REMARKS

"Marked-up" drawings

FIG. 3

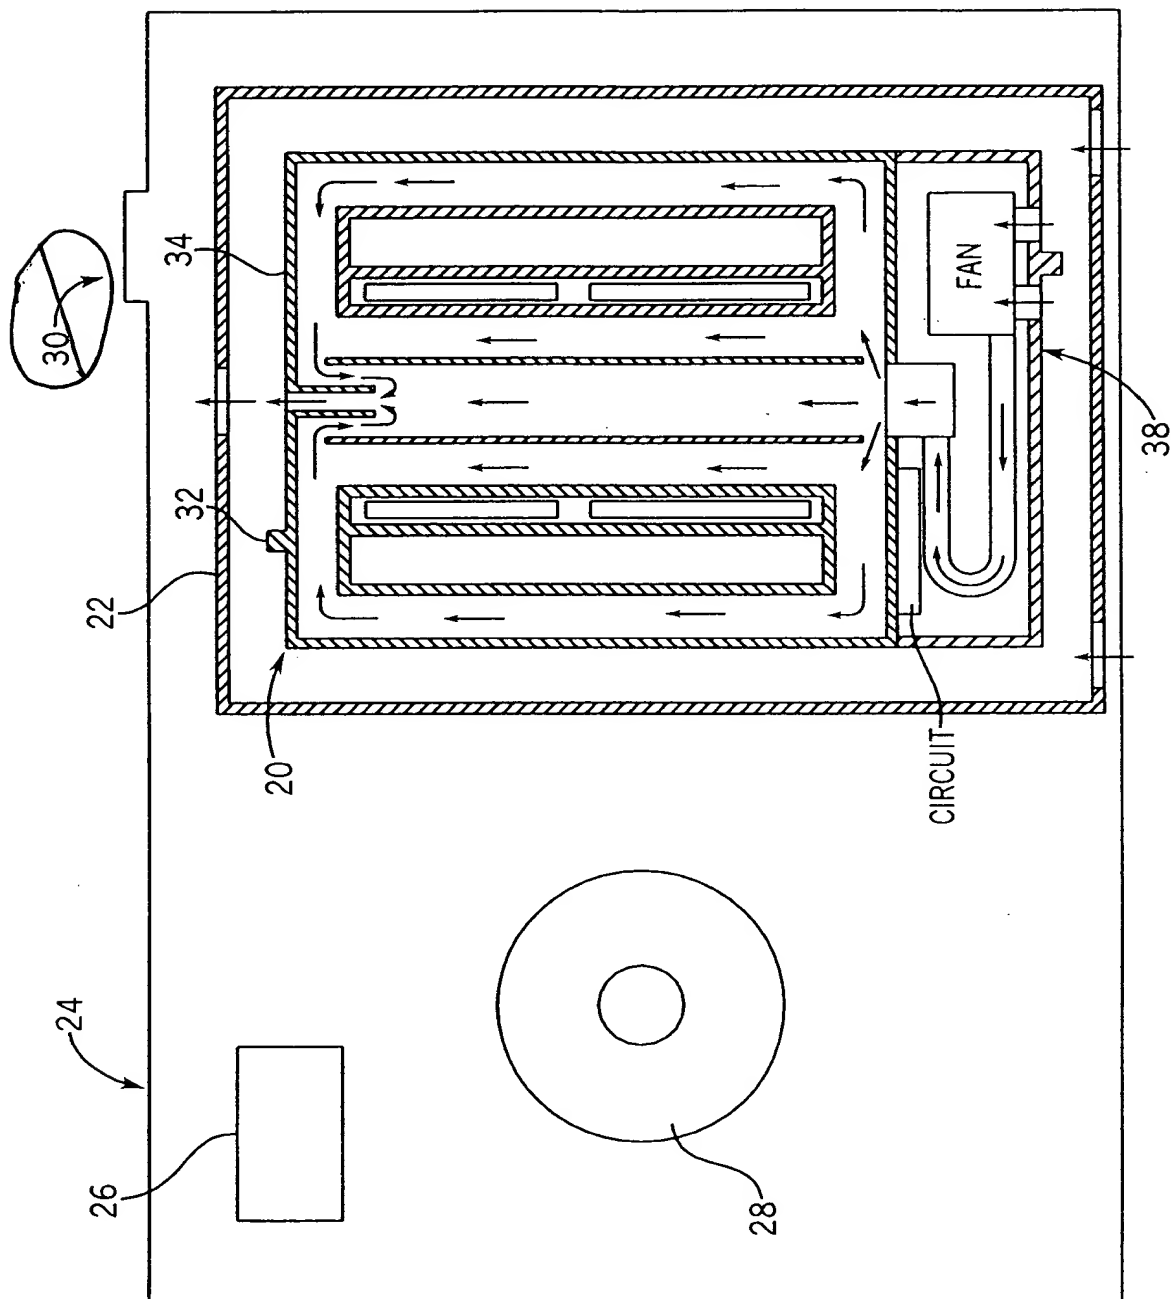
4) Reference numeral 30 of Fig. 3 is not described in the application. Reference numeral 30 has been removed from the drawings.

FIG. 4

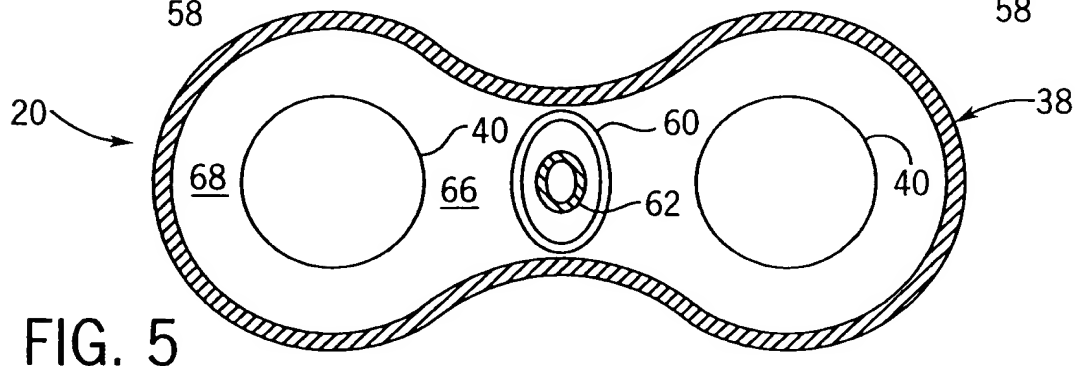
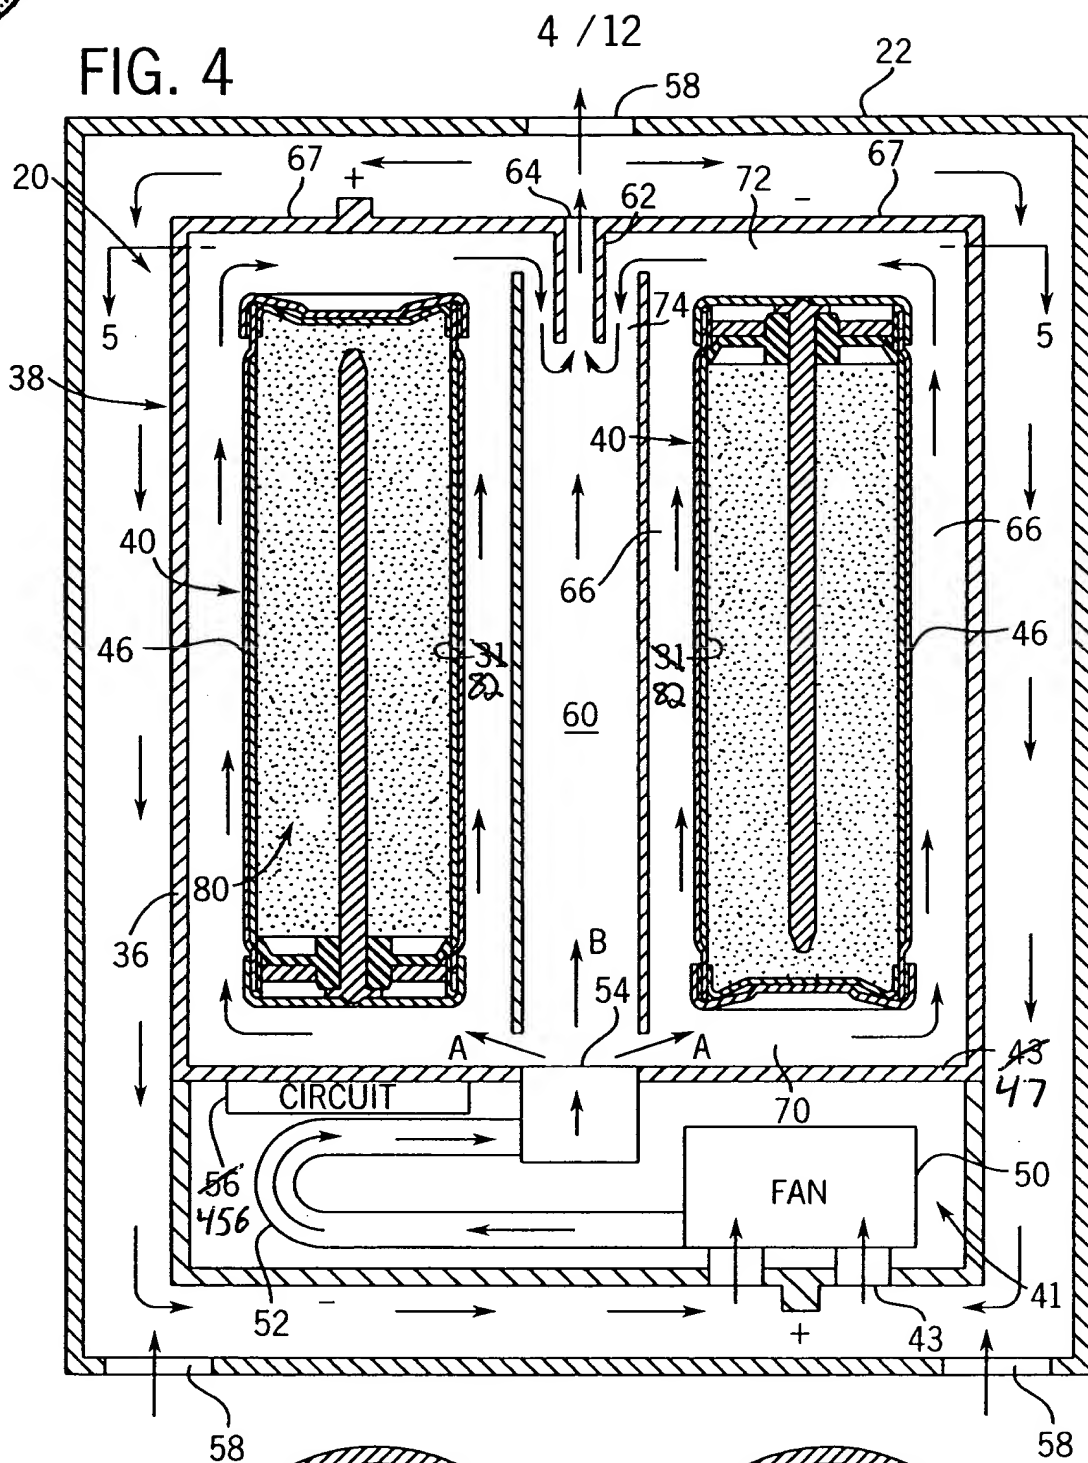
5) Reference numeral 31 of Fig. 4 is not described in the drawings. Reference numeral 31, 131, 231, and 331 of Figs. 4 and 7-9, respectively, have been changed to 82, 182, 282, and 382 for the purposes of consistency with Fig. 10.

8) Reference character "243" appears to be drawn to 2 distinct portions of Fig. 8. Applicant further notes that reference numerals 43, 143, and 343 are drawn to the same distinct portions in Figs. 4, 7, and 9, respectively. Applicant therefore amends Figs. 4 and 7-9 to change the divider plate 43, 143, 243, and 343, respectively, to 47, 147, 247, and 347. Applicant has further amended Paragraphs 56 and 61 of the present application to reflect the drawing changes.

2) Reference character 456 is not in the drawings. In the enclosed “marked-up” copy of Fig. 6, Applicant has drawn a red circle around reference numeral 456 to illustrate that numeral 456 was in the drawings as initially filed. Applicant further encloses marked-up copies of Figs. 4 and 7-9 that, in red ink, change the enumerated circuit “~~56~~, ~~156~~, ~~256~~, and ~~356~~” to “456” for the purposes of consistency with Fig. 6.

FIG. 6

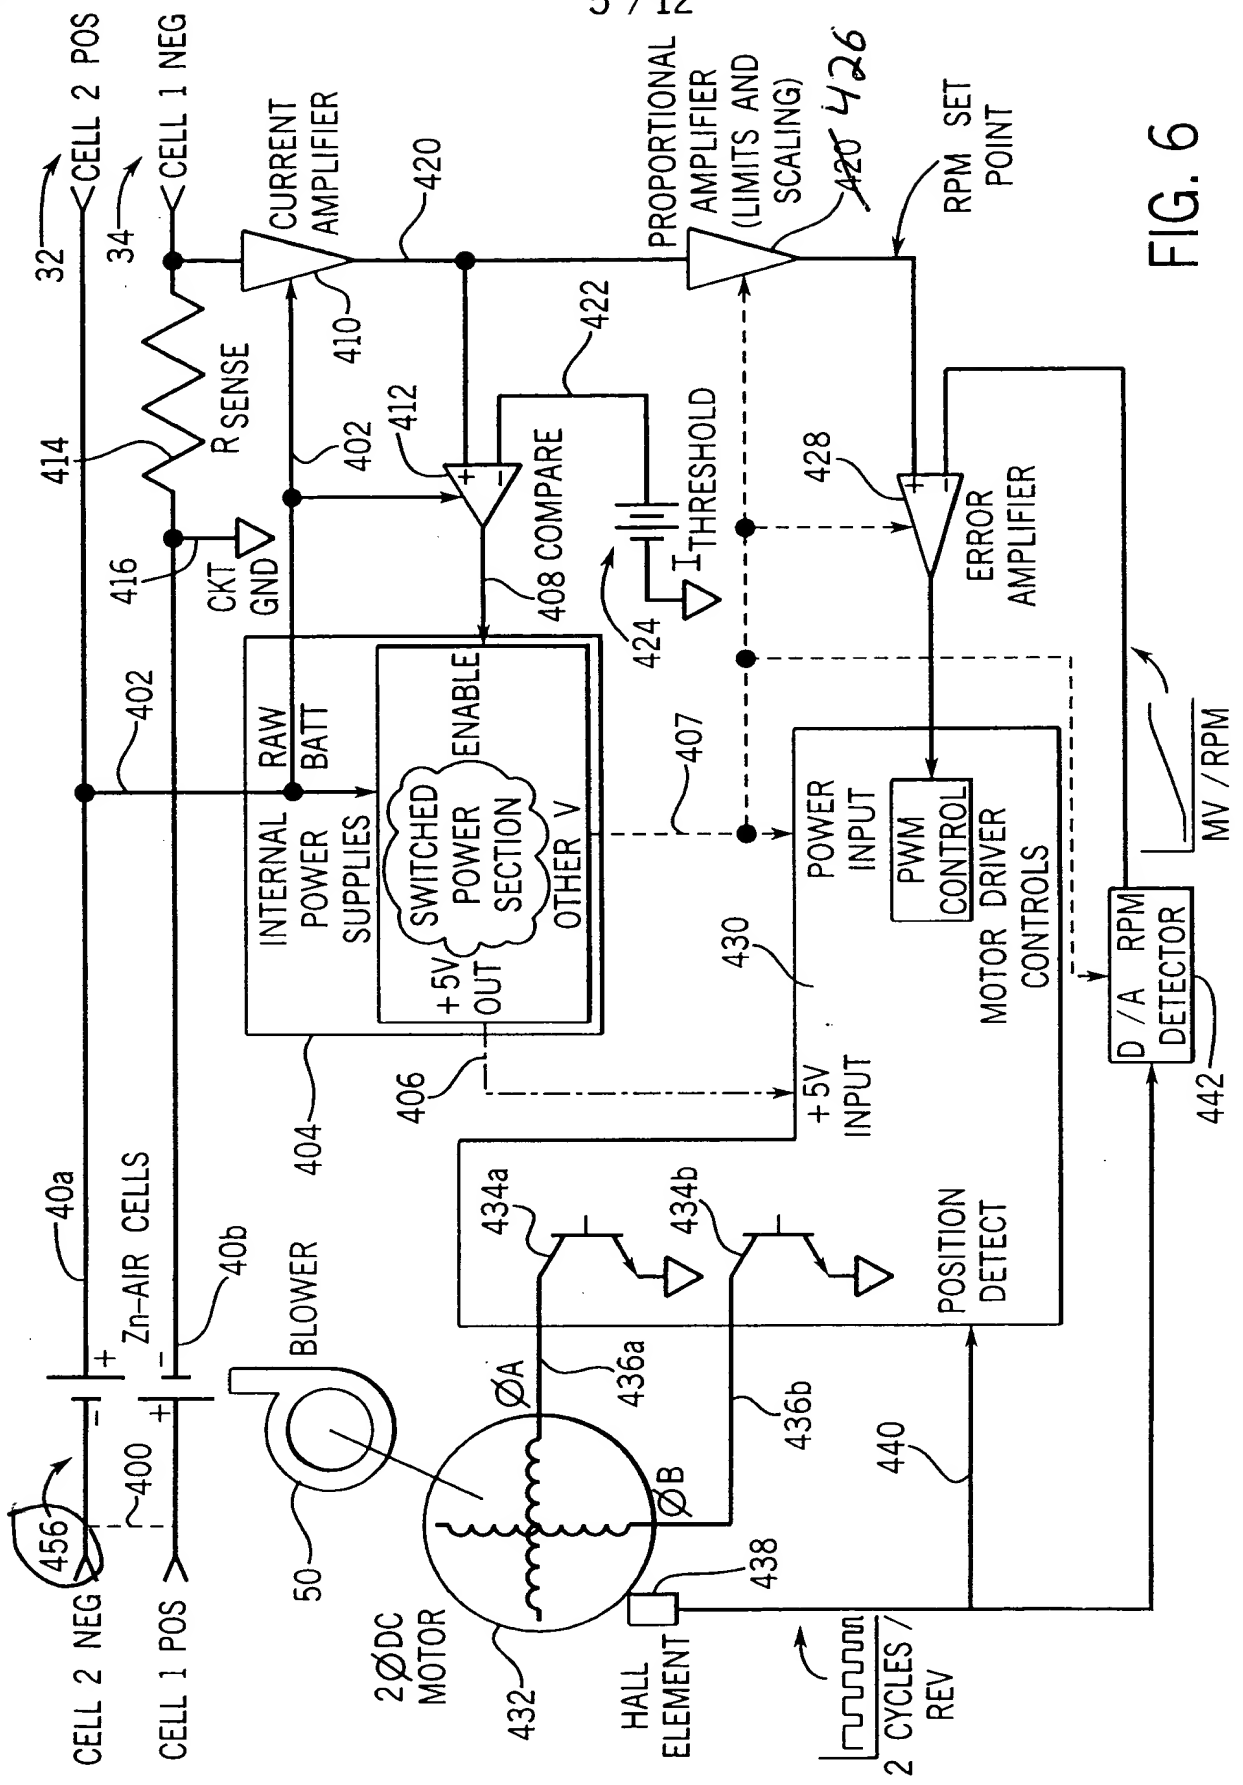
7) Reference character 420 in Fig. 6 has been used to designate both the current amplifier and the proportional amplifier. Applicant has changed the proportional amplifier 420 to 426. This correction is supported by Paragraph 74 of the specification.

FIG. 7

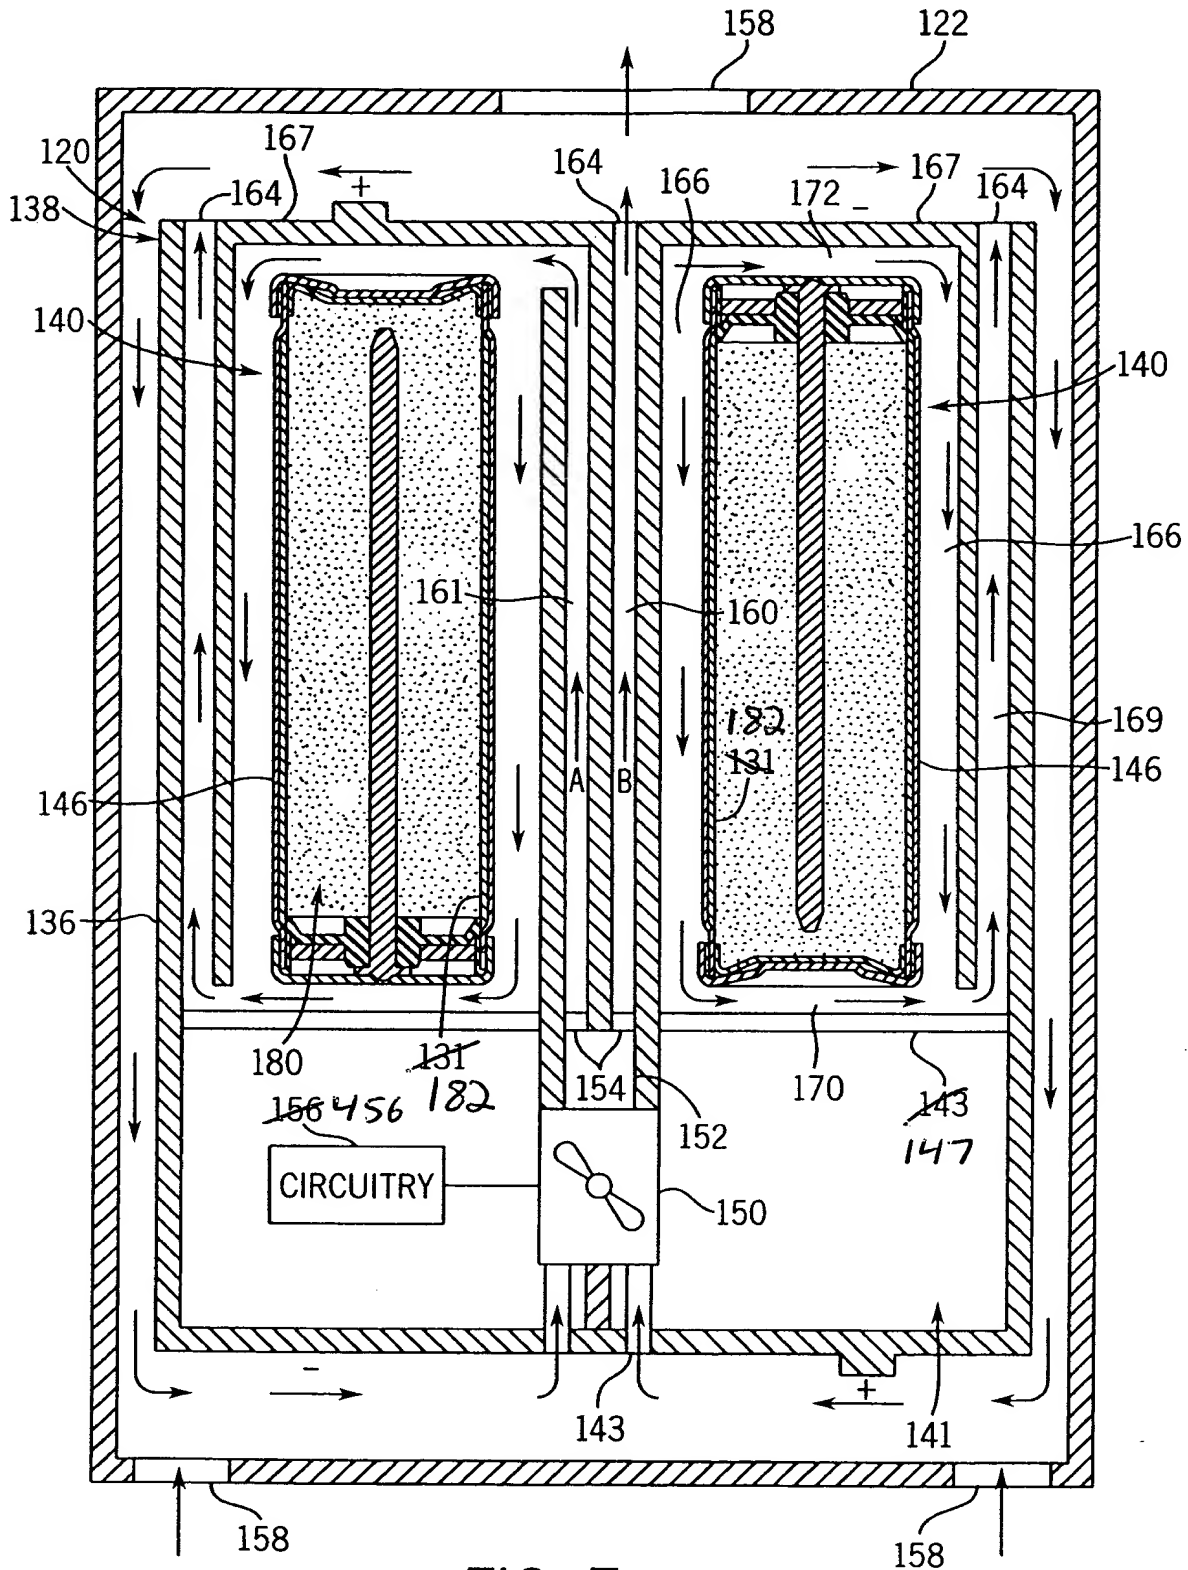
6) The Office action calls out numerous reference numerals of Figs. 7-9 that are not mentioned in the description. However, Applicant notes that all identified reference numerals are incremented from reference numerals of Fig. 4 that are specifically called out in Paragraphs 61-68 of the specification. Applicant further directs the Examiner's attention to Paragraphs 78, 81, and 83, which specifically state that the reference numerals of 7-9 corresponding to like elements of Fig. 4 have been incremented by 100, 200, and 300, respectively. Accordingly, Applicant asserts the description of Fig. 4 is sufficient for the purposes of describing the like elements of Figs. 7-9.

FIG. 8

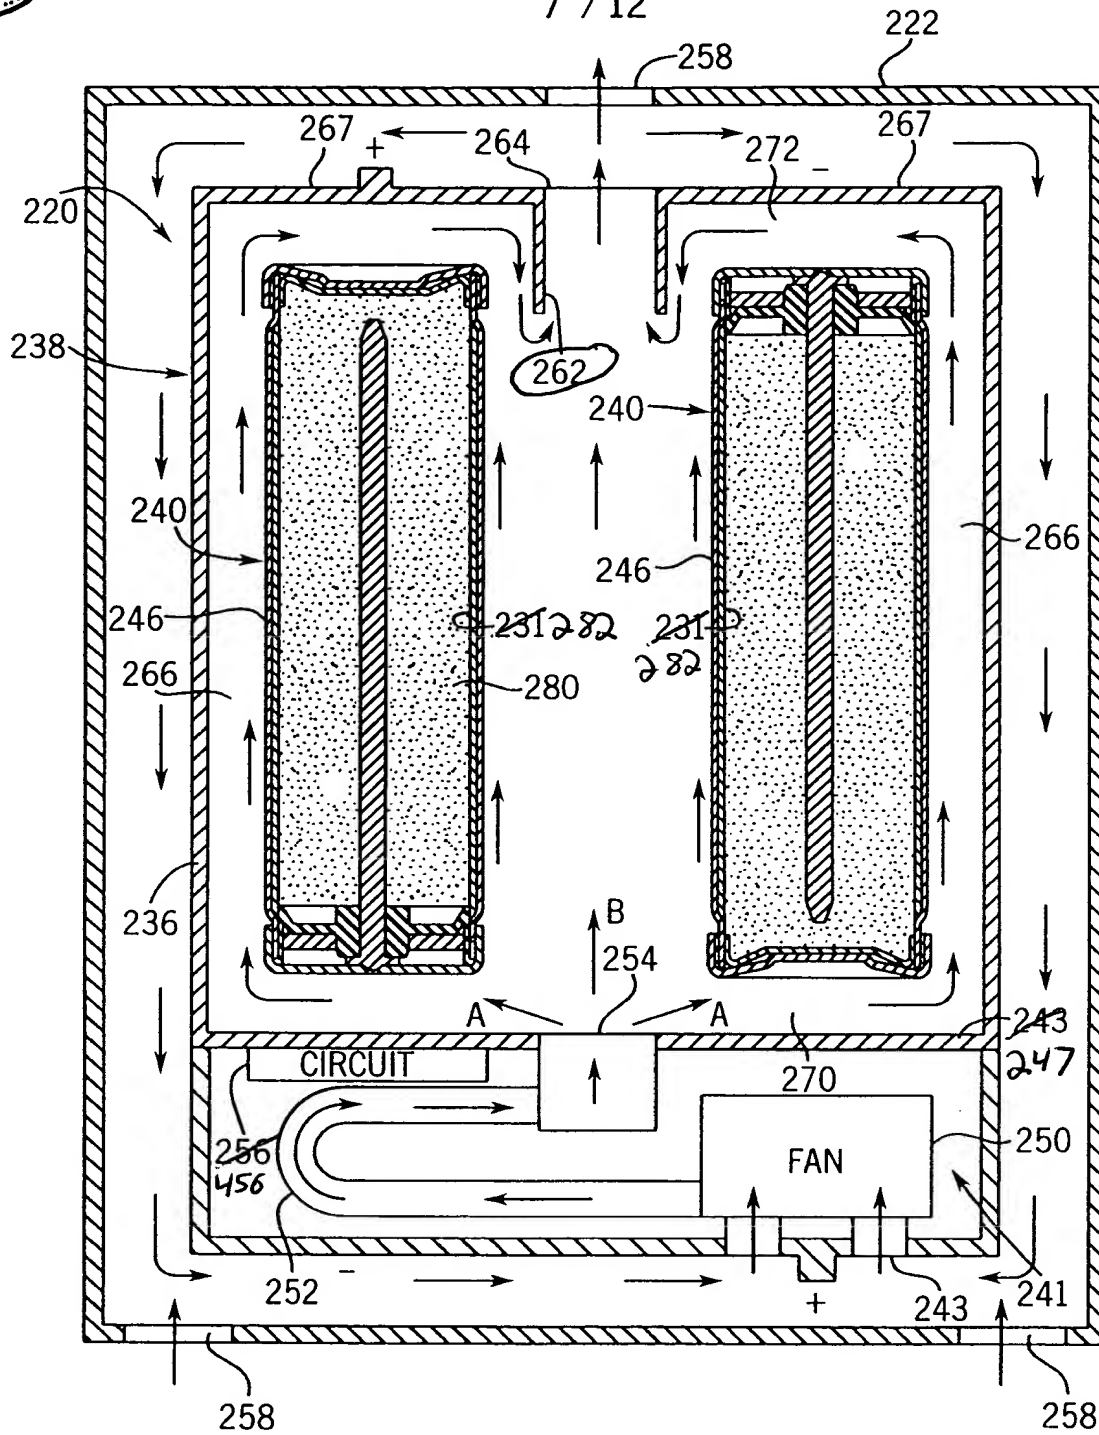
3) Reference character “262” is not found in Fig. 8. Applicant has drawn a red circle around reference numeral “262” to illustrate that numeral 262 was in the drawings as initially filed.
